HOWARD COUNTY HEALTH DEPARTMENT

RECEIPT DATE: 3/2/20 ONSITE SEWAGE DISPOSAL SYSTEM P 567331

PROPERTY ADDRESS: 12420 Hill Crest

contractor copy - add trench

+1 NEW TRENCH

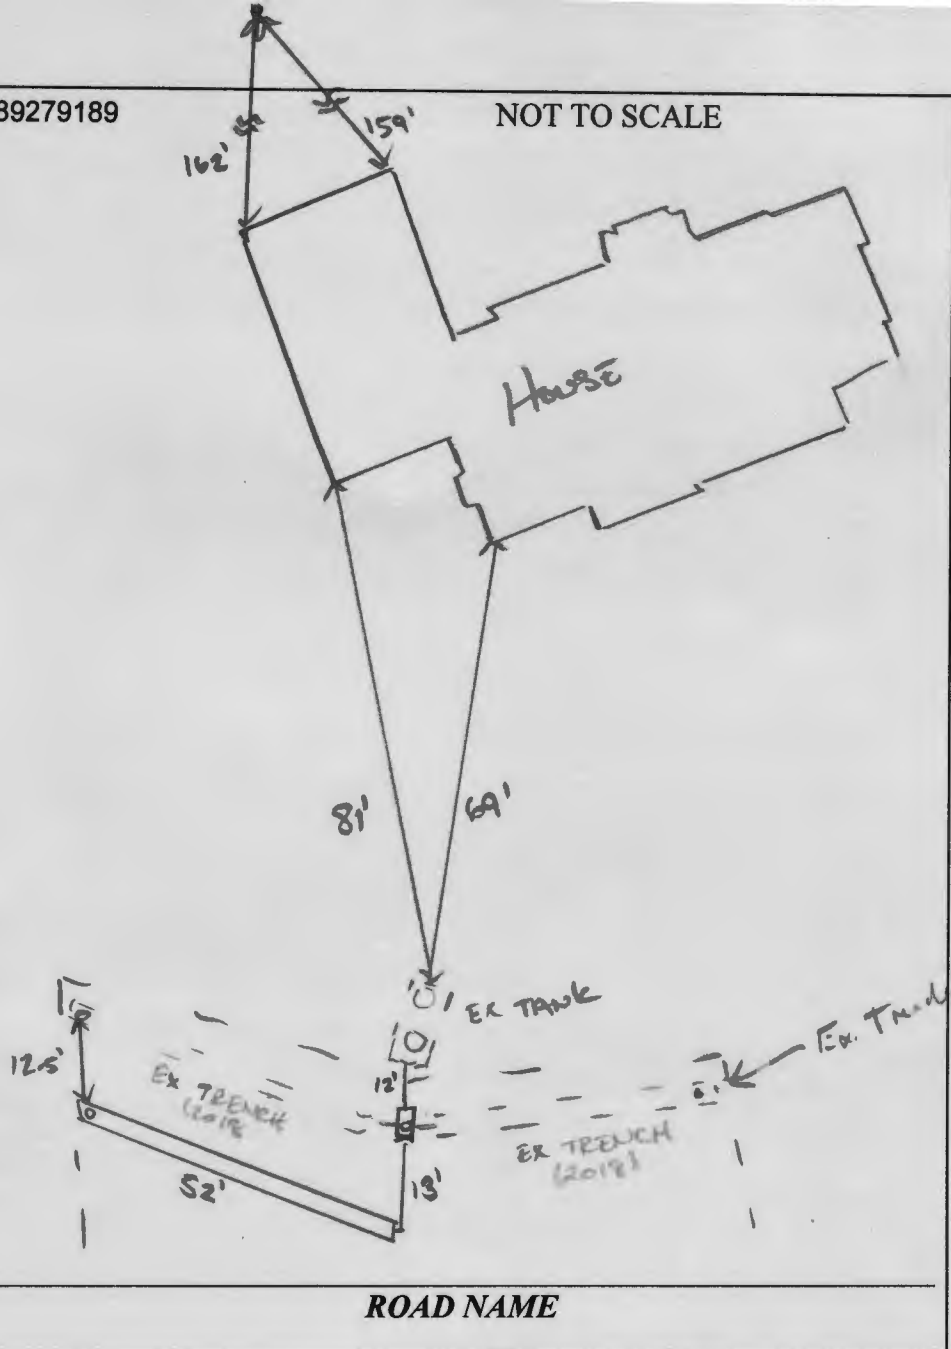
3/17/2020 gave contractor 'OK' to install 52' trench just below existing system. call for inspection plan

INSTALLATION: 03/18/2020 NEW TRENCH INSTALLED 1x 52' 3' INLET 6' DEEP. D box leveled w/ SPEED LEVELS to

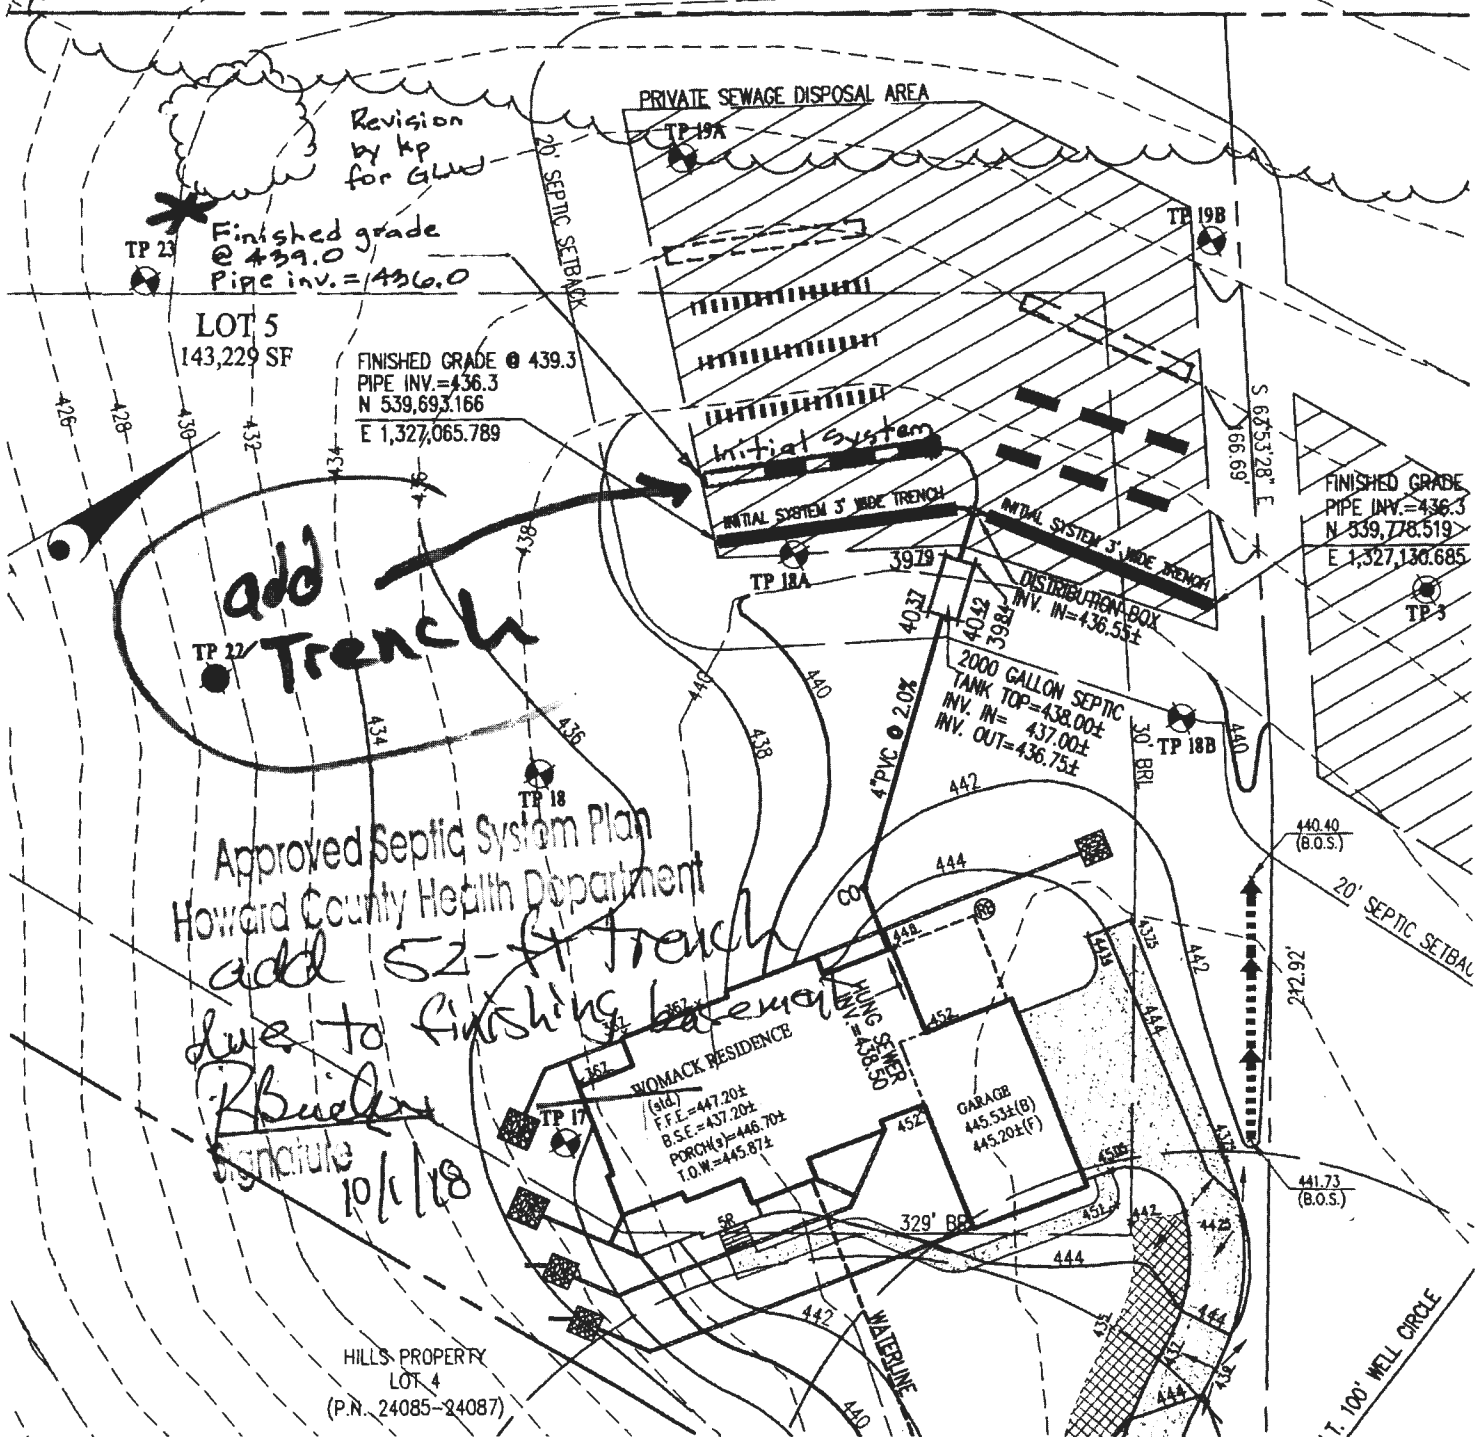
Revision by kp for GLW
* Finished grade @ 439.0
Pipe inv. = 436.0

add Trench

Approved Septic System Plan
Howard County Health Department
add 52-ft trench
due to finishing basement
K. Budler
Signature
10/1/18
